## Vehicle Owner Notification

**To:** All Dealers  
**From:** Tracy Daniels  
Warranty Department  
**Subject:** VON #82 – Heater/Defroster 2 Fuse Replacement  
**Date:** January 31, 2013

## VEHICLE OWNER NOTIFICATION #82

**MODEL:** SAF-T-LINER MVP-EF  
**SUBJECT:** HEATER / DEFROSTER FUSE REPLACEMENT  
**DATE:** JANUARY 31, 2013  
**ACTIVE PERIOD:** 1/31/2013 – 1/30/2014  
**EXPIRES ON:** 1/31/2014  
**PAGE:** 1 OF 2

**FIGURE 2**

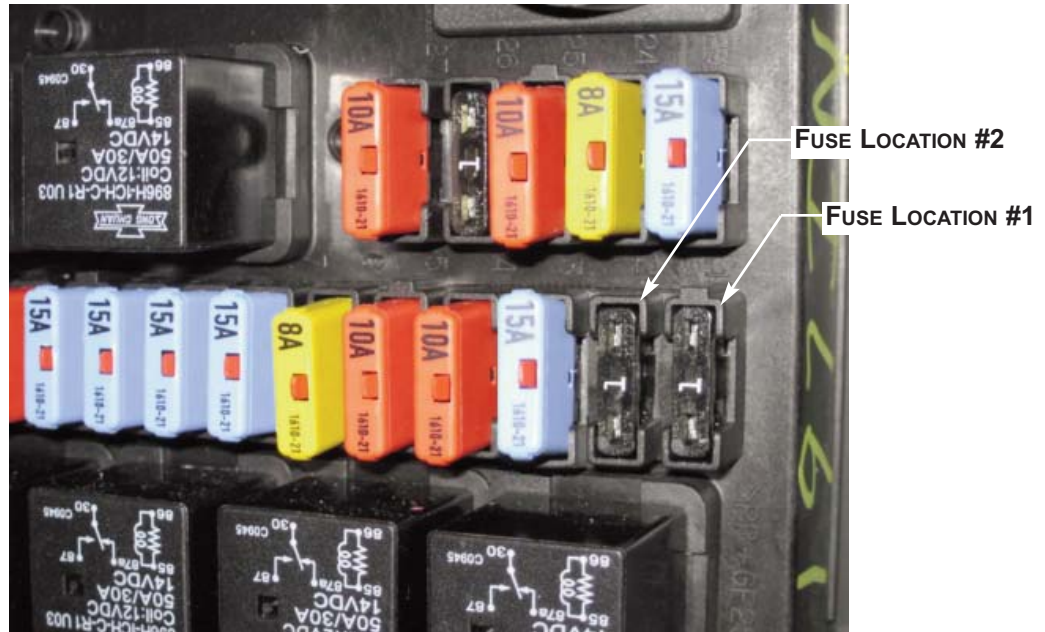
Enclosed is a copy of the customer notification letter being prepared for your customers who have purchased certain Saf-T-Liner MVP-EF units manufactured from October 6, 2003 through May 5, 2008. It has been determined that the fuse for the heater/defroster is the incorrect size. The correct fuse is a 1 AMP.

4. Locate the fuse or circuit breaker in locations #1 and 2 on PC Board #1 and replace it with a 1 amp fuse - TBB 151450. **FIGURE 2**

<b><u>PART NUMBER</u></b>	<b><u>QTY.</u></b>	<b><u>DESCRIPTION</u></b>
TBB 151450	2	1 AMP ATC FUSE
